# Access Compliance Report

## Public Rights-of-Way

Intersection ID: 10031405	Main Street: MCALPINE_PARK_DR	Cross Street: N/A	Location: NW
ADA ID: F14C44A907A8	Ramp Type: PerpDiag	Initial Pass/Fail: Fail	Overall Compliance: No
Severity Score: 33.75			
Codes/Mitigation Info/Possible Solution		Field Measurements/Component Compliance

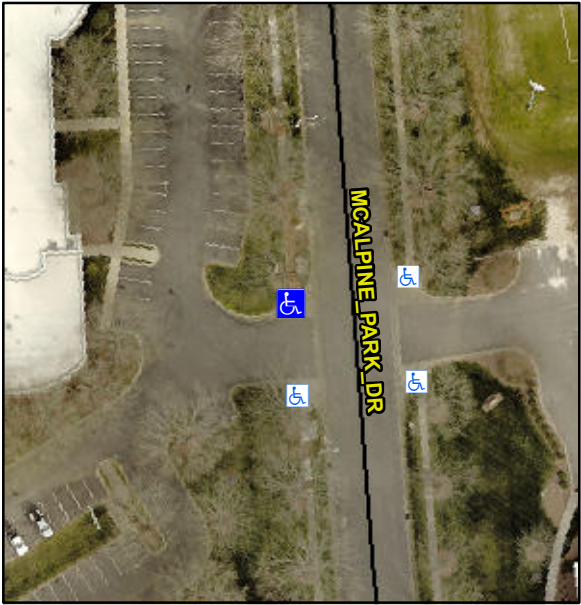
Possible Solutions:		Compliance	Description	Data	Compliance	Description	Data
	Remove & Replace Curb Ramp With Two New Directional Ramps or Equivalent.		N/A	Ramp Length (in)	65.5	No	Ramp Slope (%)	9.6
<p>Surveyor Notes:</p> <p>N/A</p> <p>PROW/ADA:</p> <p>Not Found, R304.5.1, R304.2.2, R304.5.3</p>			No	Ramp Width (in)	45.0	No	Ramp XSlope (%)	6.4
			N/A	Flare Type LT	N/A	N/A	Flare Type RT	N/A
<p>Street 1 Name</p> <p>ENTRANCE</p> <p>Stop Condition-Street 2</p> <p>None</p> <p>Street 2 Name</p> <p>MCALPINE PARK DR</p> <p>Stop Condition-Street 1</p> <p>None</p>			N/A	Flare Slope LT (%)	N/A	N/A	Flare Slope RT (%)	N/A
			N/A	Flare Traversable LT?	N/A	N/A	Flare Traversable RT?	N/A
<p>Total Cost:</p> <p>\$ 3200.00</p>			N/A	Landing Length (in)	N/A	N/A	DWS Provided?	N/A
			N/A	Landing Width (in)	N/A	N/A	DWS Contrast?	N/A
			N/A	Landing Slope (%)	N/A	N/A	DWS Length (in)	N/A
			N/A	Landing X Slope (%)	N/A	N/A	DWS Full Width?	N/A
